Land West of Market St, Edenfield (H66)  
Masterplan submitted by Taylor Wimpey

## Responses Received

H66 Masterplan (Taylor Wimpey, 2022)

### **Representations about Masterplan Proposed by Taylor Wimpey H66 Land West of Market Street, Edenfield**

Figure 1- Proposed character areas by Randall Thorp for Taylor Wimpey (left) and draft character areas identified by AECOM for ECNF (right)

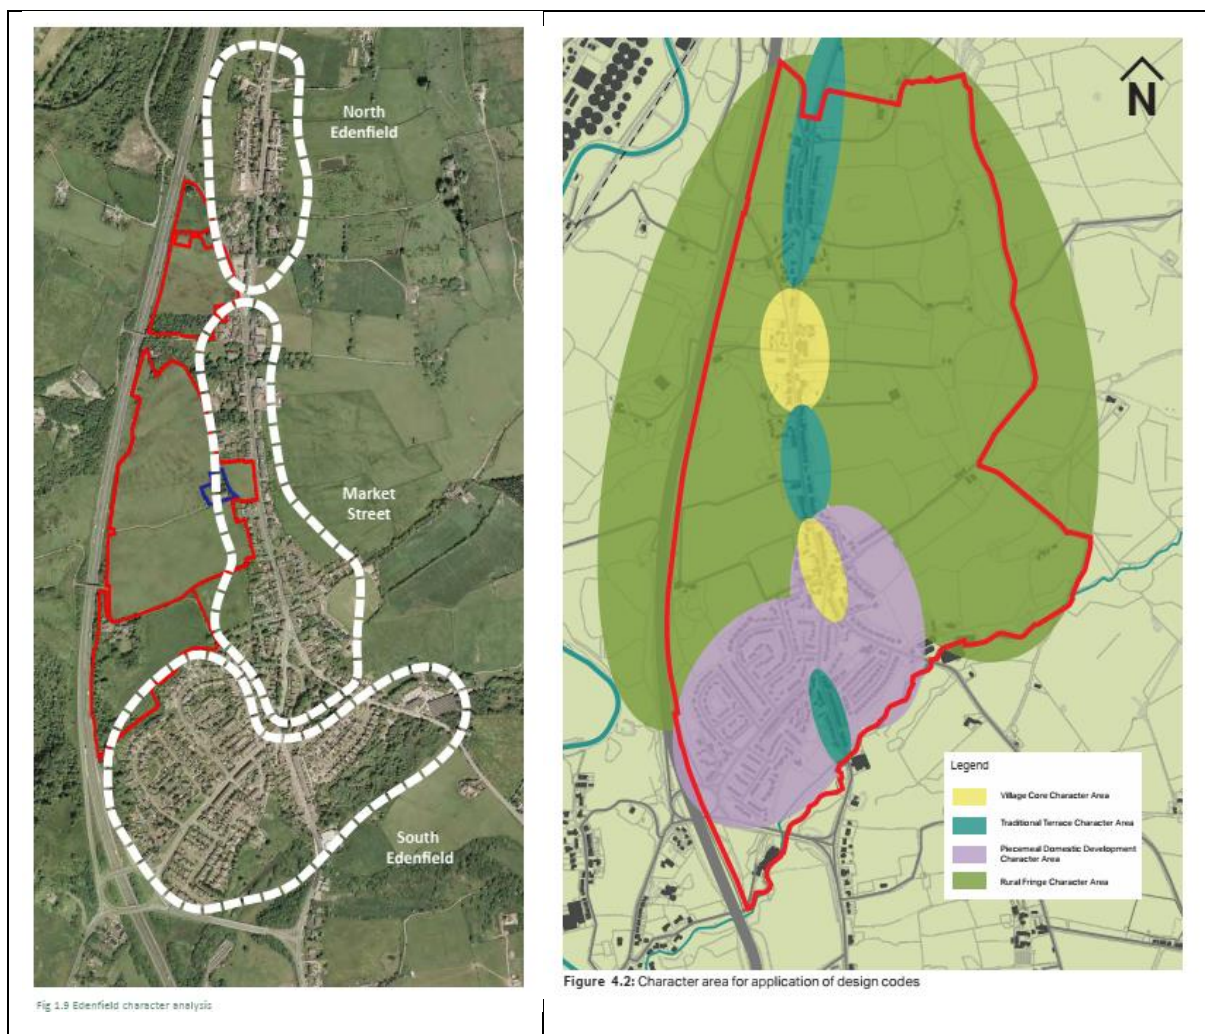
The Masterplan and Design Code identifies 3 character areas for the existing Edenfield settlement: north Edenfield, Market Street and South Edenfield. The identification of these character areas is slightly different from the ones proposed in the draft Design Code of the Neighbourhood Plan where four character areas for the Neighbourhood Area have been identified. These are: the village cores, the traditional terraces, the piecemeal domestic development mainly in south Edenfield and the rural fringe. This is shown on the diagram below:

Figure 2- Indicative block/area densities in Edenfield

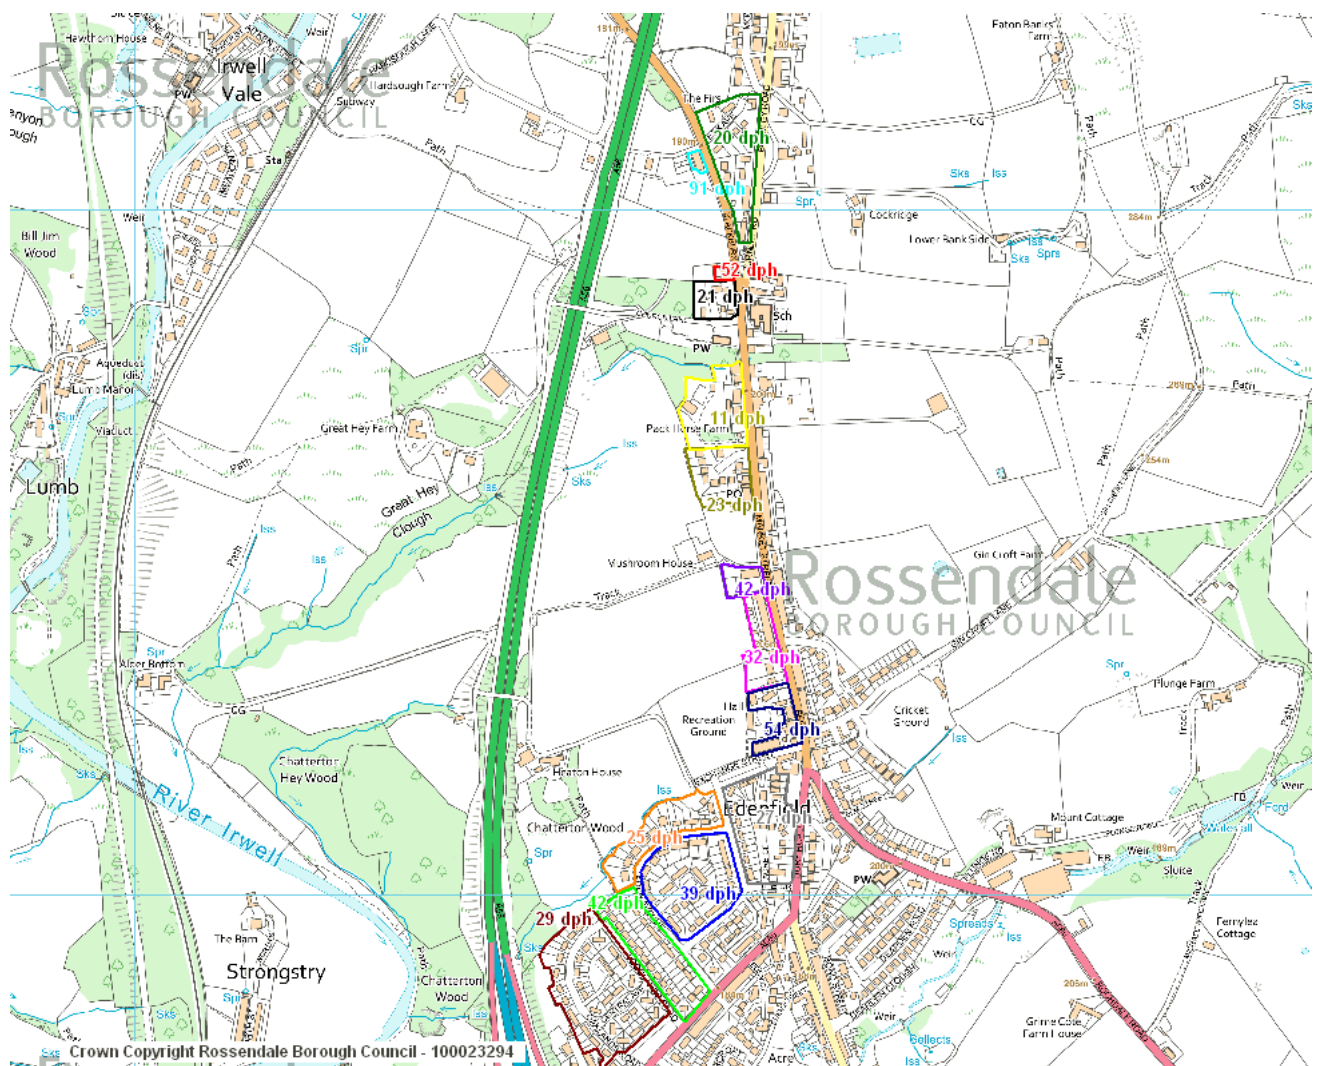
In the site allocation Design Code, the site is envisaged to be developed according to 4 new character areas: Edenfield Core, Chatterton Fringe, Chatterton South and Edenfield North. These 4 areas are proposed to have different, although quite similar, densities ranging from 32 to 34 dwellings per hectare (dph) in 'Edenfield North' character area to 36 to 45 dph in 'Chatterton South'.

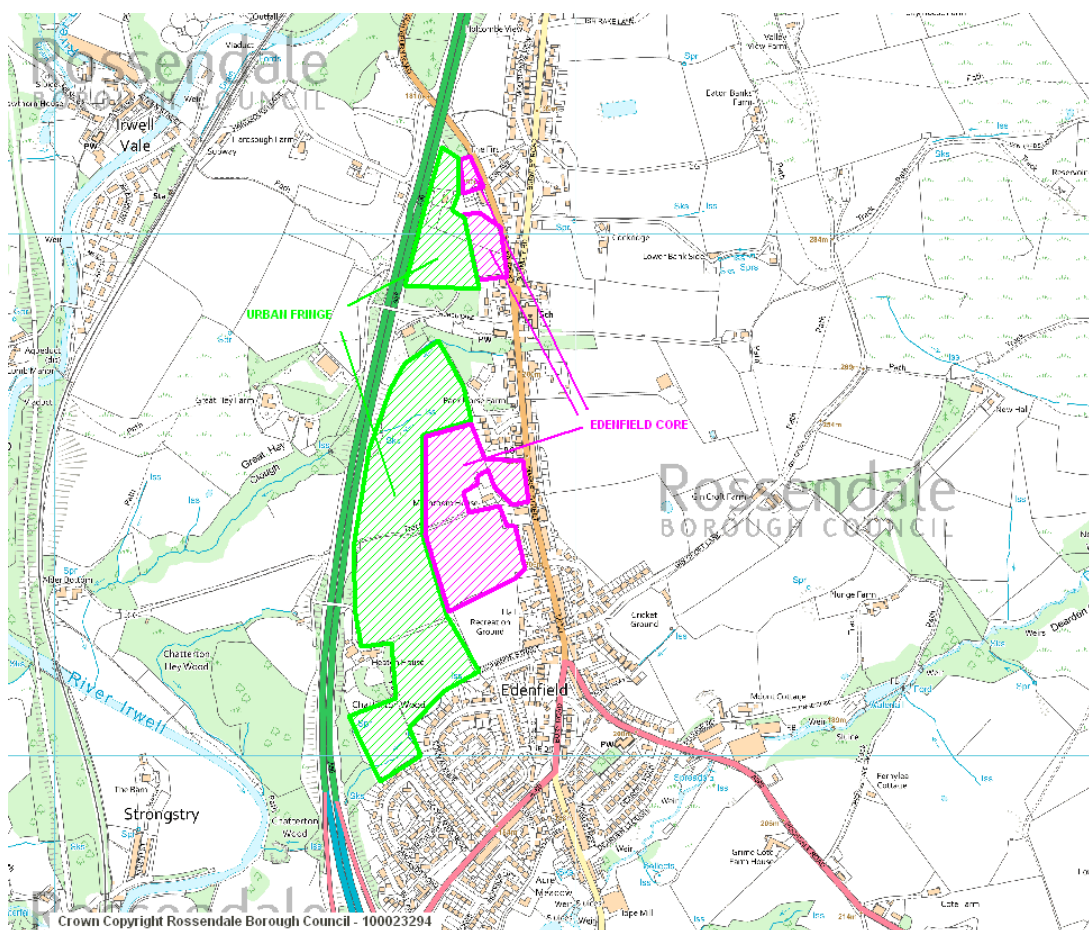
‘Edenfield North’ is proposed to have the lowest density to reflect its ‘position at northern fringe of Edenfield’. However, the draft Design Code of the Neighbourhood Area identifies a second village core at the junction between Blackburn Road with Market Street close to Edenfield Primary School. In addition, the average density of some blocks in proximity to the site have an average density of 55 dph. Therefore, it is thought that the density of the development in this parcel could be increased including the provision of terraced housing along Blackburn Road.

The northern part of the site does not have any designated character areas attributed and this should be addressed. The most relevant character is considered to be the 'Chatterton Fringe' (or 'Urban Fringe') as it will provide a smooth transition between the new development and the remainder of the Green Belt.
